July 25, 2016

BOARD OF COUNTY COMMISSIONERS
ORANGE COUNTY, FLORIDA

ADDENDUM NO. 4 / IFB NO. Y16-776-PH
INTERNATIONAL DRIVE POTABLE WATER BOOSTER PUMP STATION

SCALE: 1" = 20'
DRAWING NO.: **C102**
SHEET: 8 OF 49

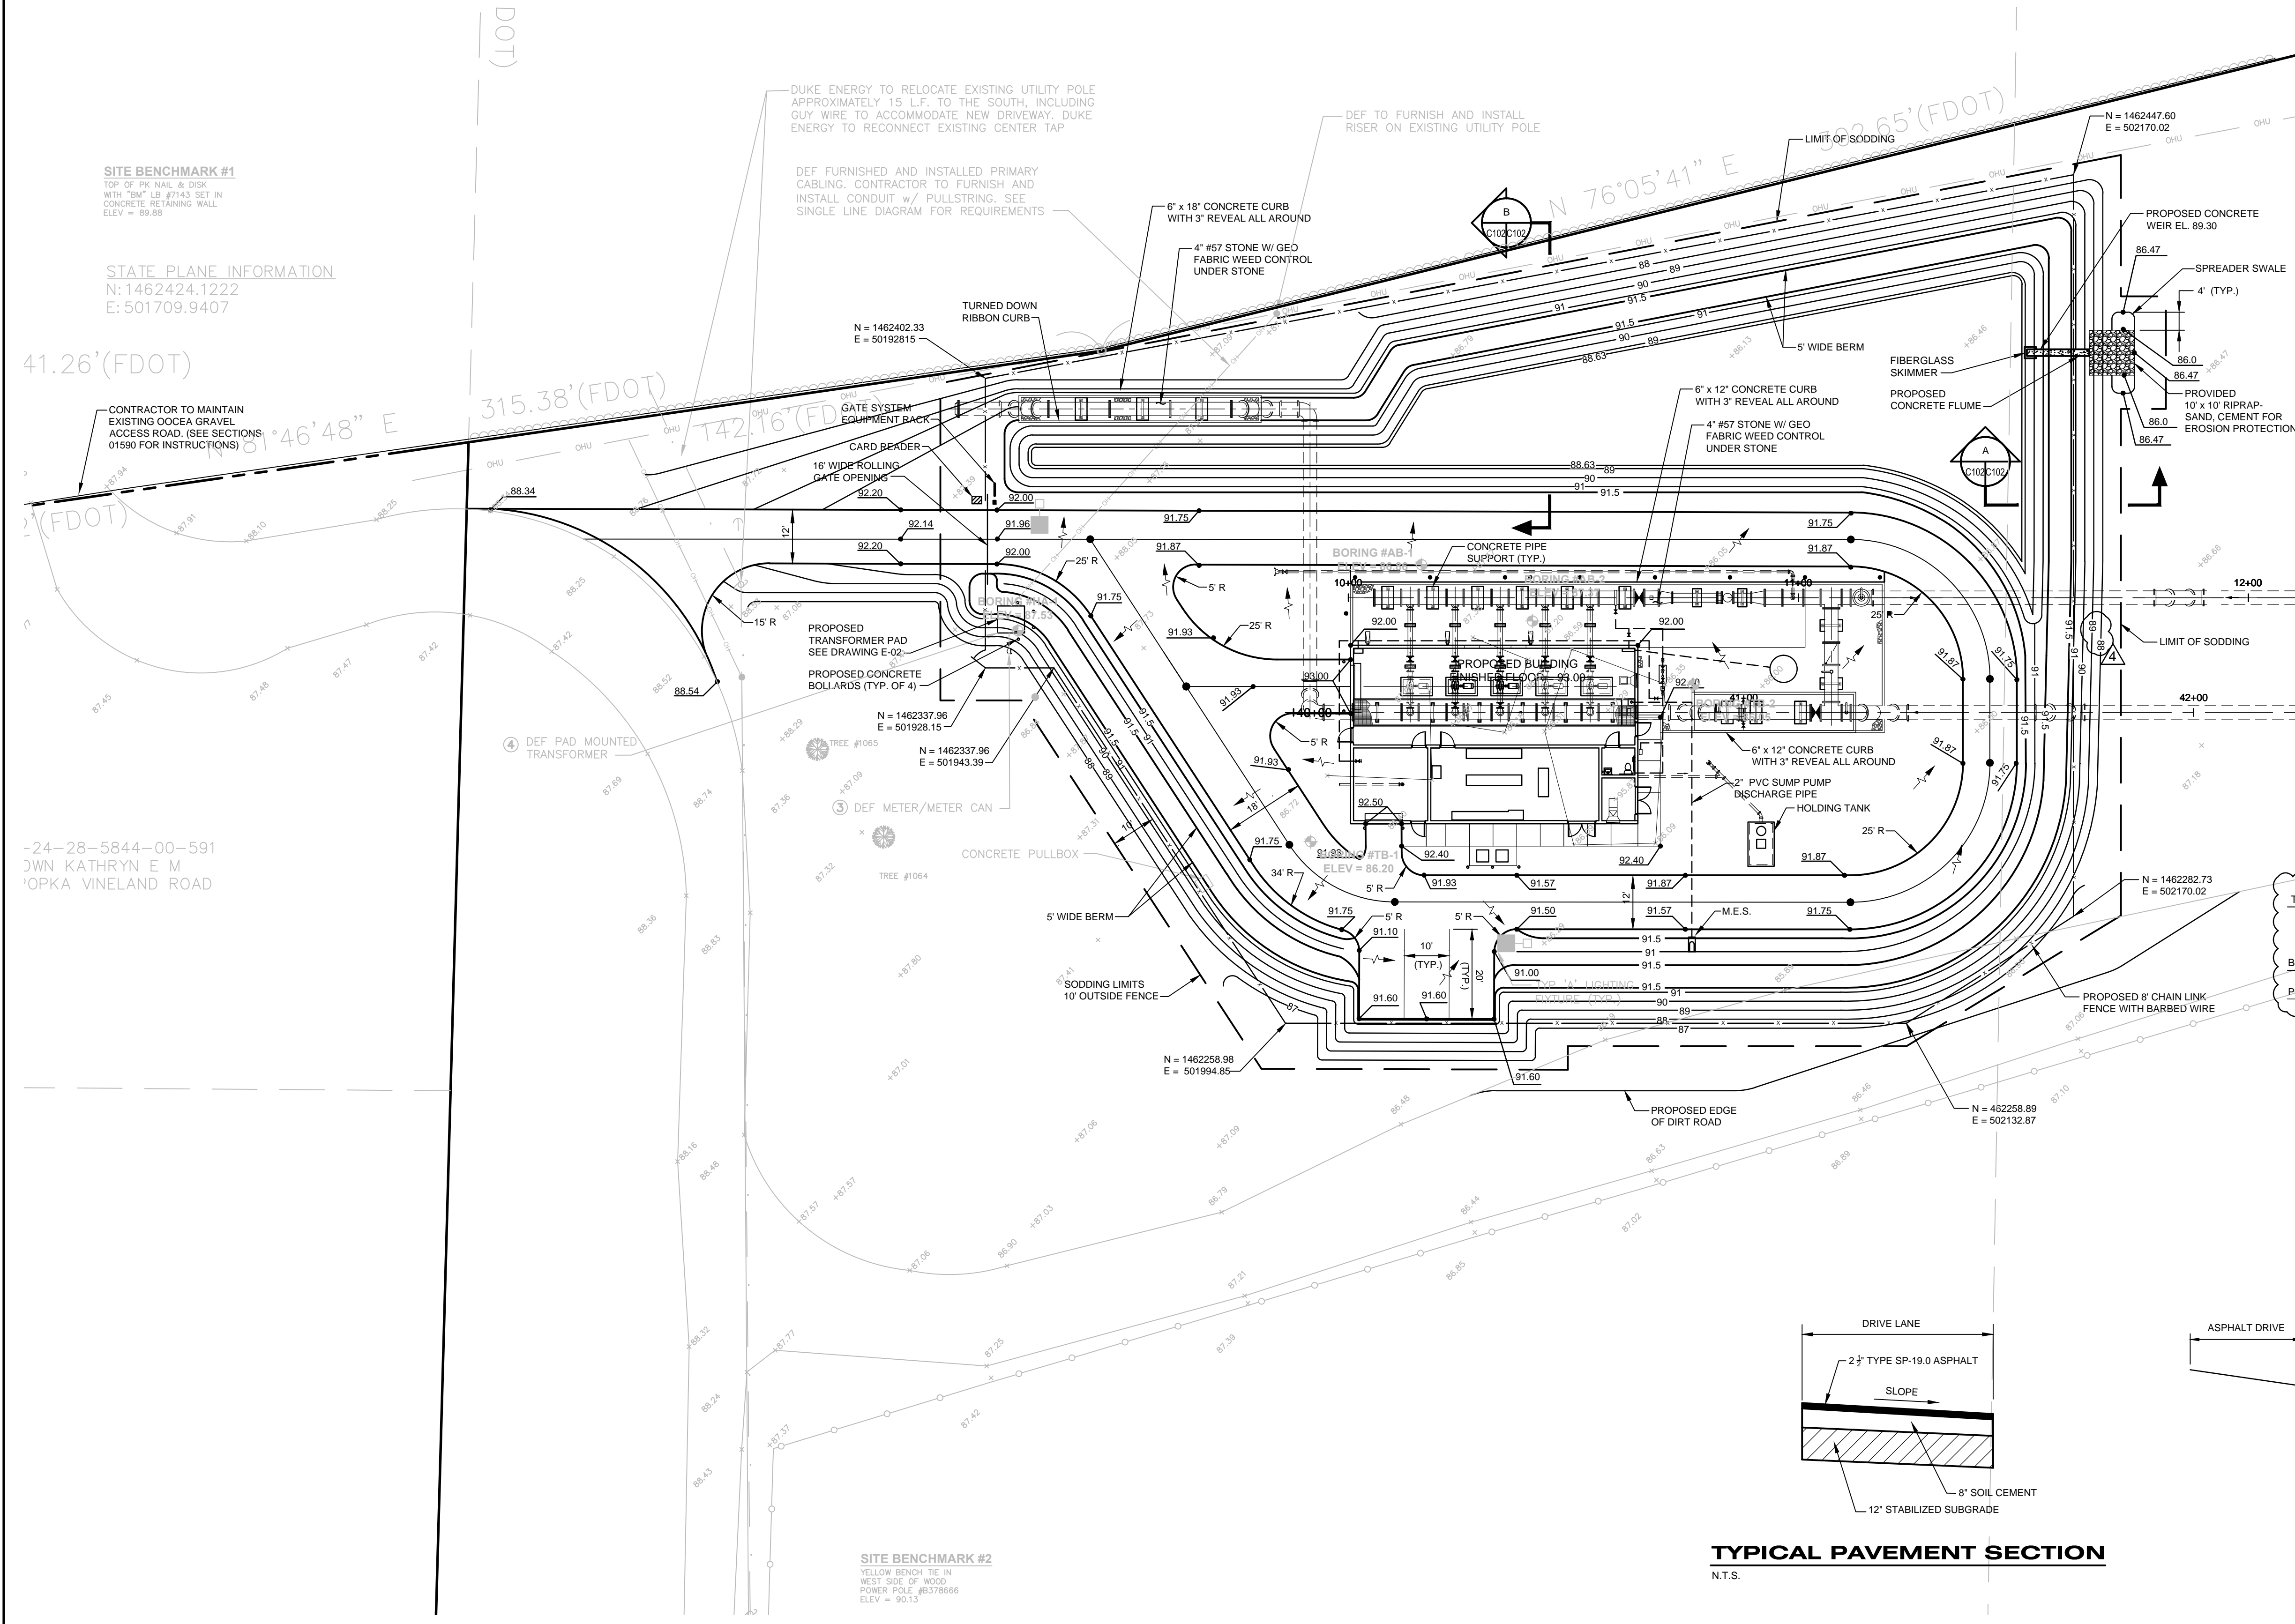
- 20. Q: Please clarify the weir/concrete flume/fiberglass skimmer detail on C102. It appears that the flume should be 6’ wide based on the skimmer dimensions and plan view not 18’ as shown in the detail.**

Amend: Modified Weir Section.

A: Concrete weir is to be 18” wide, not 18’ wide. See revised Drawing C102.

SCALE: AS NOTED:
DRAWING NO.: **E-09**
SHEET: 33 OF 49

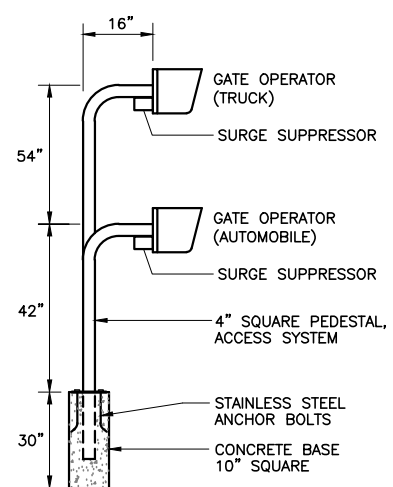
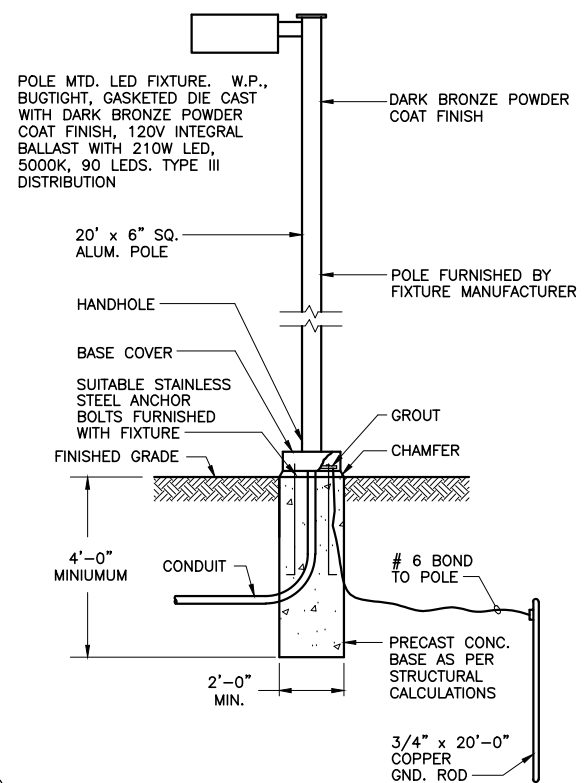
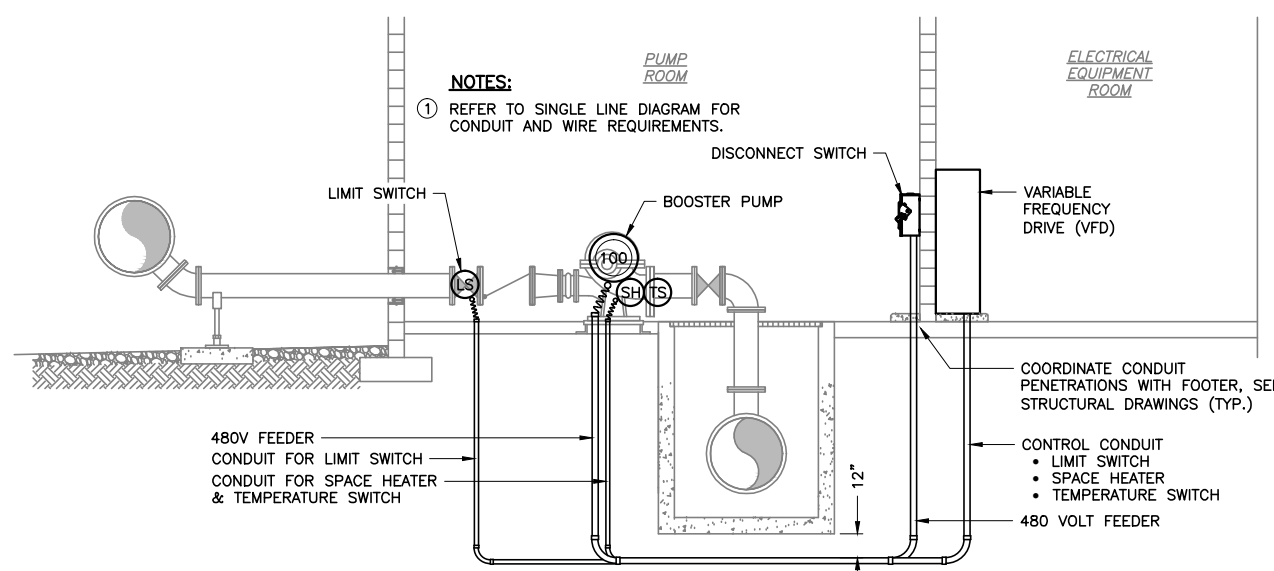
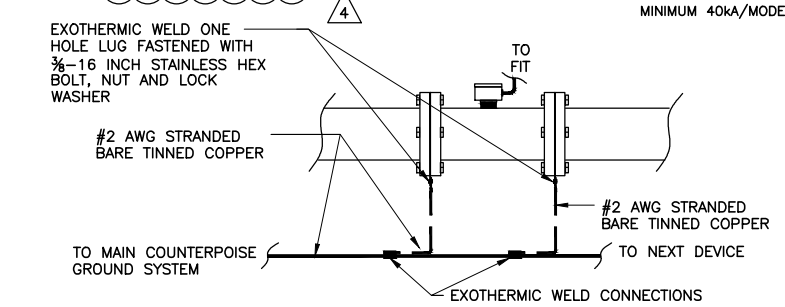
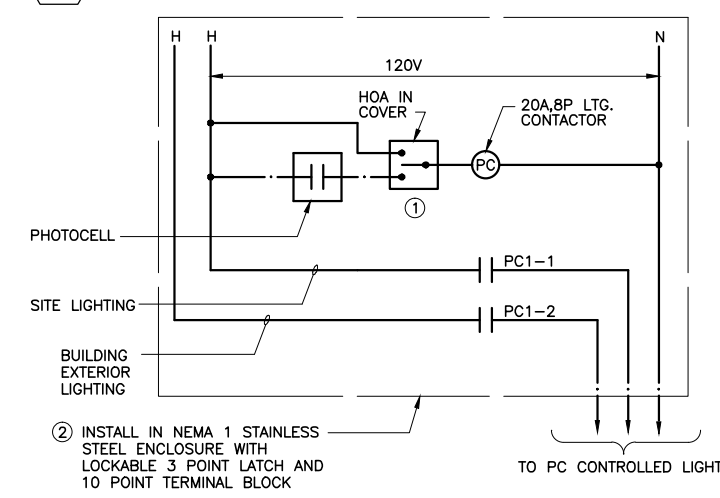
DRAWING E-09

Replace in its entirety.
